ANN ARBOR HISTORIC DISTRICT COMMISSION

Staff Report

ADDRESS: 112-114 W Liberty Street, Application Number HDC18-026

DISTRICT: Main Street Historic District

HDC 2

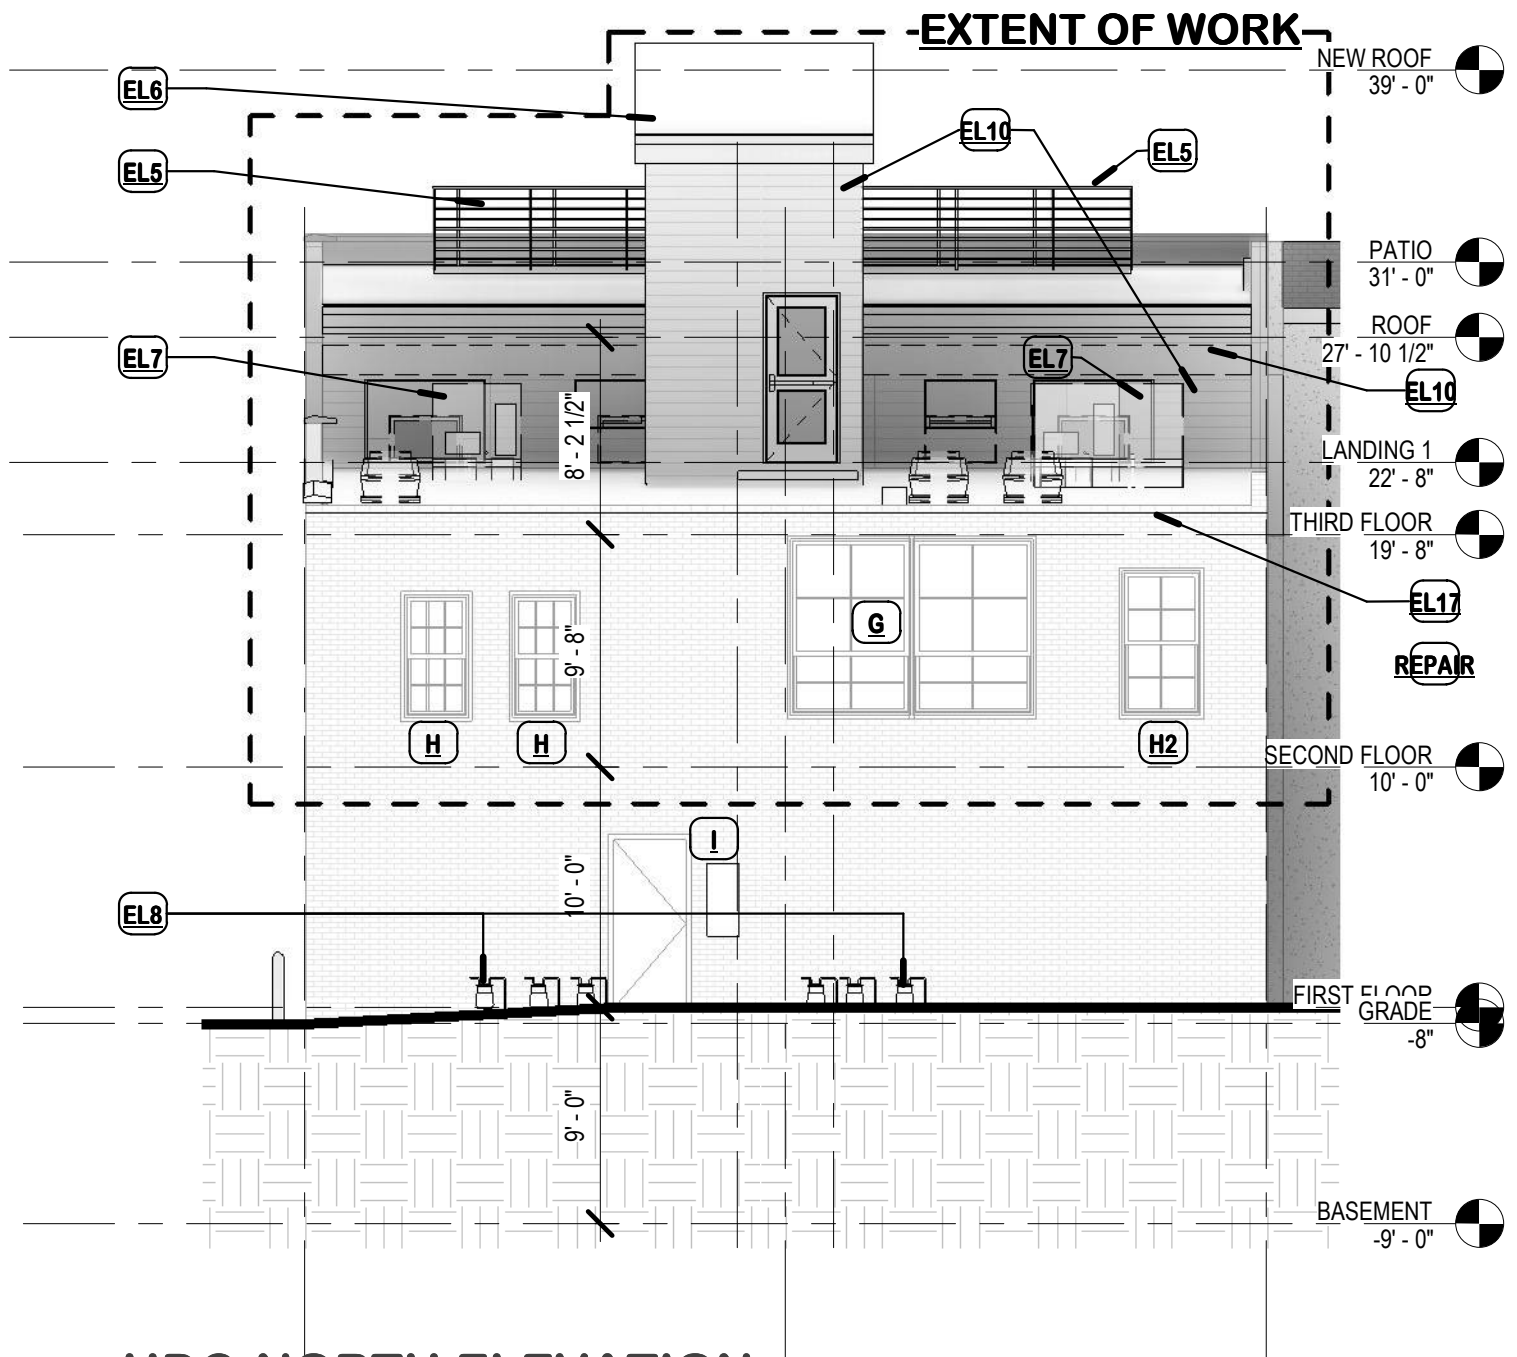
4. Windows A and B on the front elevation of 114 were previously replaced. Installing new replicas of windows D and E from 112's front elevation is appropriate.

5. Restoring the two window Cs is appropriate.
6. No description of the window deterioration was provided with the application. There are interior photographs of some of the windows proposed to be replaced. Whether windows D, E, F are deteriorated beyond repair will be determined by the HDC. The age and condition of G, H, and H2 will also be determined by the commission.

7. Replacing a boarded transom with a new four-lite window modeled after historic photographs is appropriate. Since no drawing of the proposed window was provided, staff will approve this at the building permit stage for consistency with the photograph.

9. The storefront features a wood trim band at the top with a hood that may have once protected awnings. The wood is proposed to be removed, and the underlying bricks repaired and tuckpointed. This is an appropriate treatment, since early photos show this band as brick. If the wood is removed and the brick band is no longer present, and a void that needs to be filled is discovered, infilling the band with 2' tall stone flatwork is appropriate, given that matching brick is not readily available. Detail of the simple profile is included.
10. Repairing or replacing damaged bricks at the corner of the building, and tuckpointing as needed, is appropriate. Any necessary infill bricks must closely match the originals.

2 BOLLARD DETAIL-

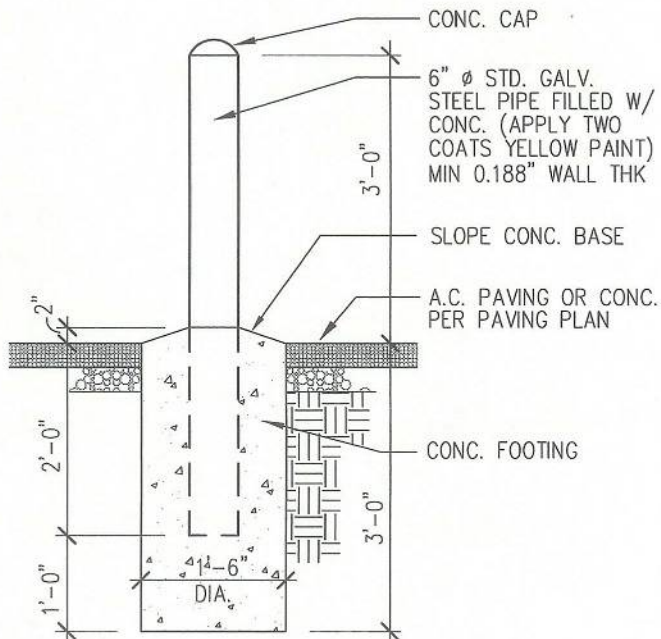
13. Installing bollards in the alley could be an effective way to protect the building. If the alley is publicly owned, appropriate authorization is required from city Building, Engineering and/or the Downtown Development Authority.

17114
112 W. LIBERTY
ST.
PER-HDC
ELEVATION
NOTES
06.04.2018
HDC 5

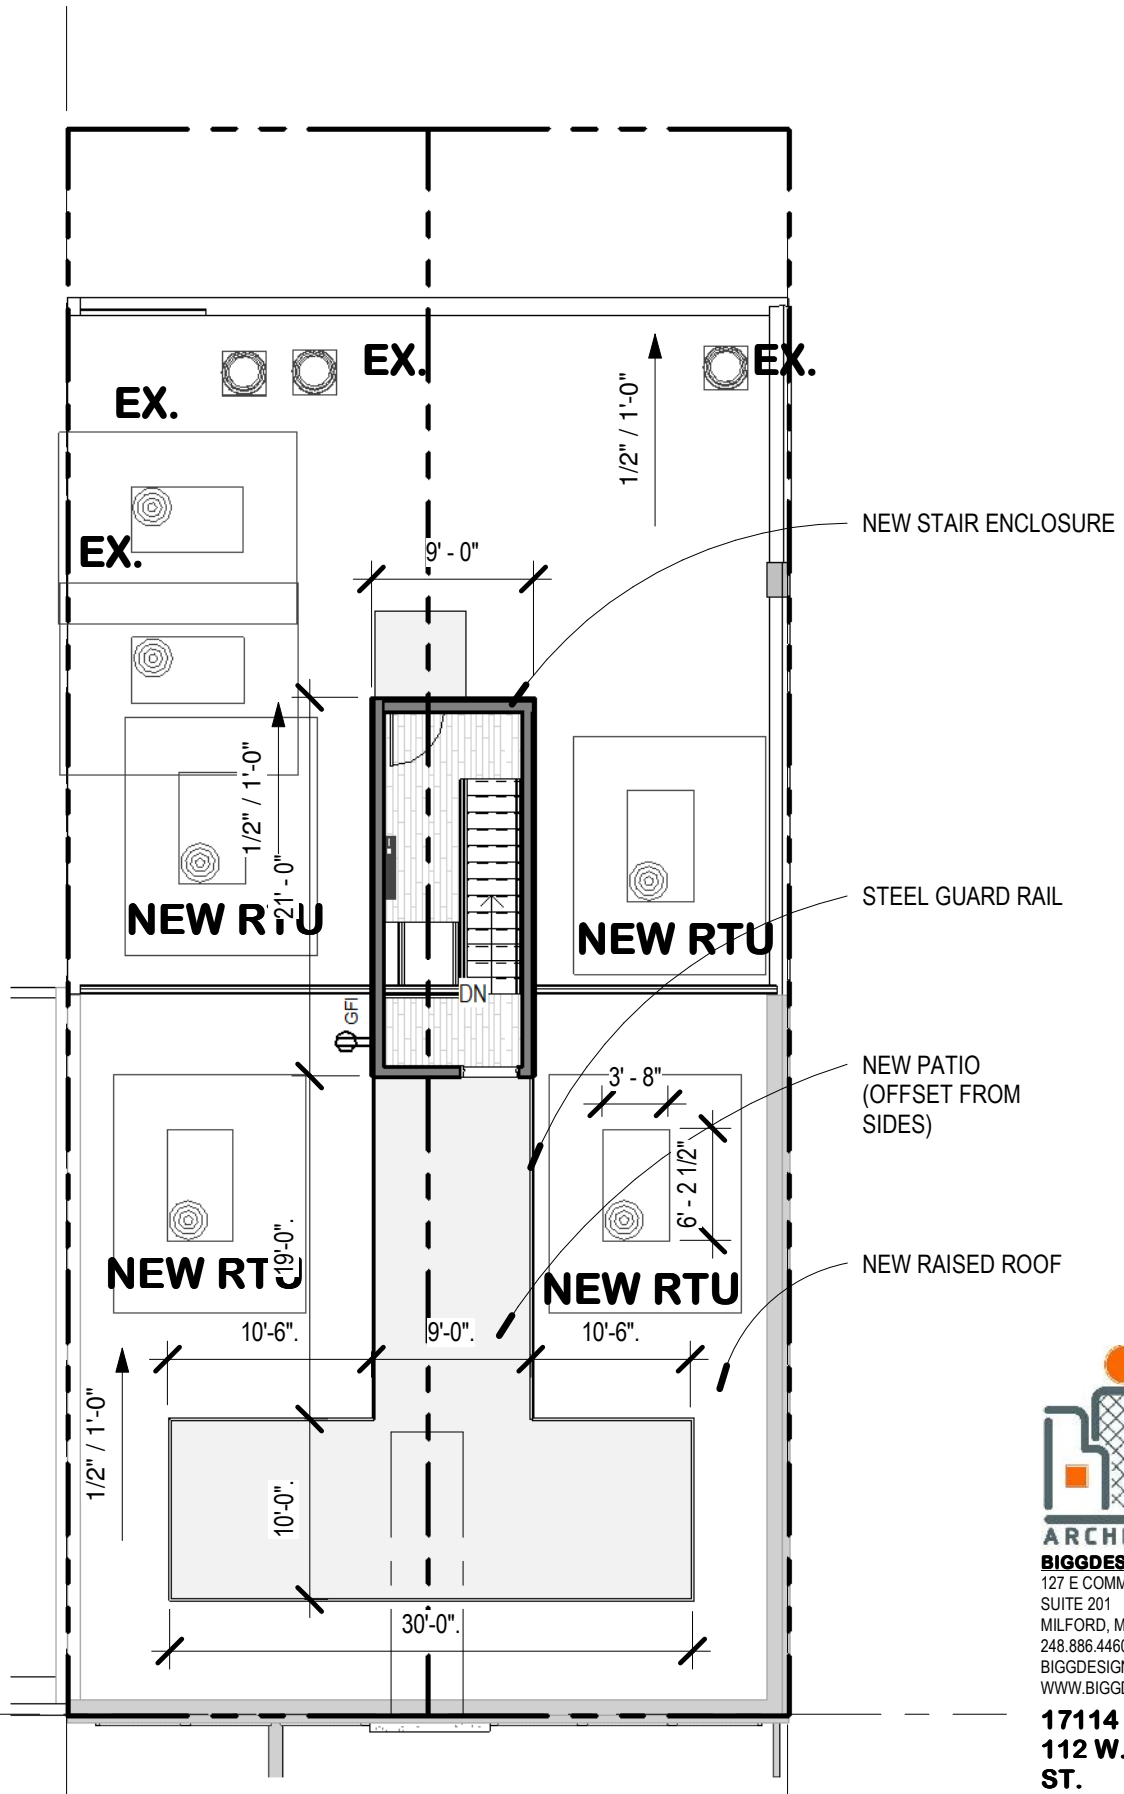
1. Window worksheets filled out for all windows proposed for replacement indicate that all dimensions will match exactly. This indicates that custom built wood windows would be installed if the HDC approves replacement. There are several profiles of Marvin clad-

2. Information in the footnotes of attachment HDC5 indicates that single-paned glass will be replaced with double-paned. This will need to be determined on a window-by-window basis; usually, original muntins are not thick enough to support two panes of glass. This is typically work undertaken on one-over-one windows, not true divided lites.

3. Footnotes 4, 5, and 6 are erroneous since the information specified has been submitted with this application. The HDC will determine whether each window is deteriorated beyond repair and therefore may be replaced.

HDC-ROOF PLAN - 112

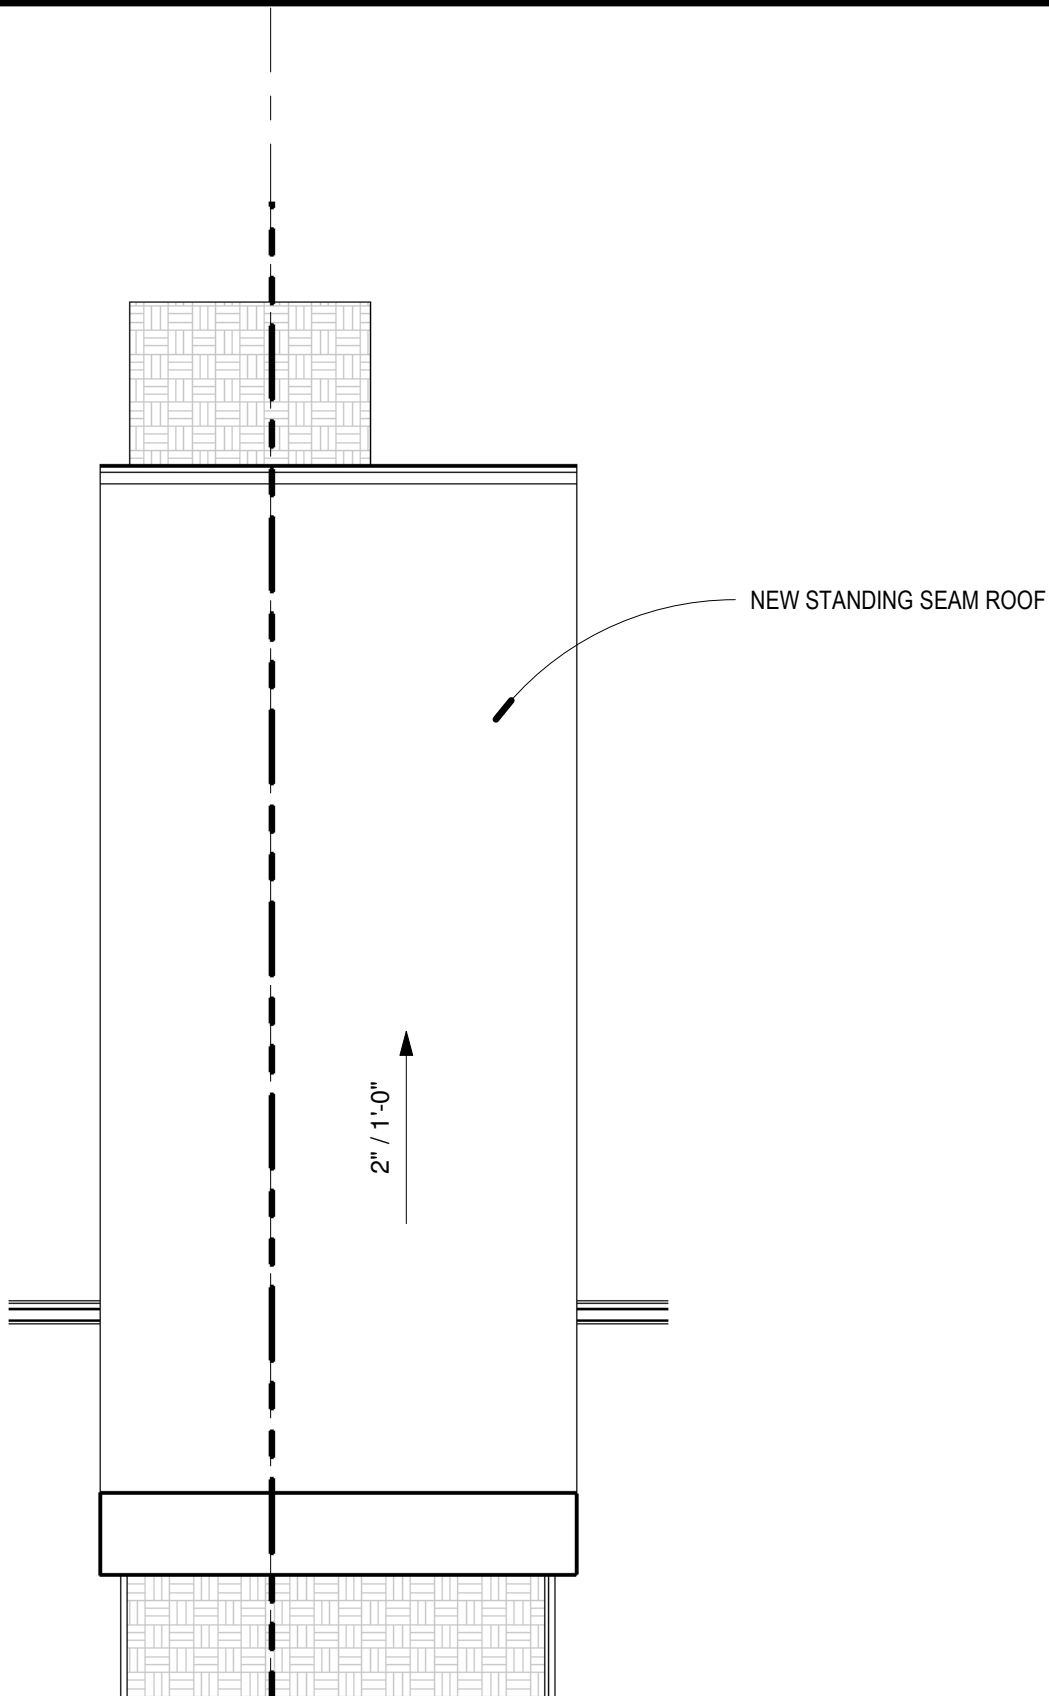
11. The proposed stair enclosure is 9' wide and 21' deep, and spans two different roof levels. It is located near the center of the building, and should be invisible from the street or sidewalk. Details of the railing system and materials (cementitious lap siding, metal roof, etc.) are included in the drawings. The deck rail is set back approximately 5' from the front parapet, and will not be visible from West Washington Street. Four new rooftop mechanical units are proposed, two on the upper and two on the lower roofs. These are out of sight and appropriate.
12. The roof work may be slightly visible from the alley north of the building, but the view from West Washington Street is blocked by the rear of a taller building between W Washington and W Liberty.
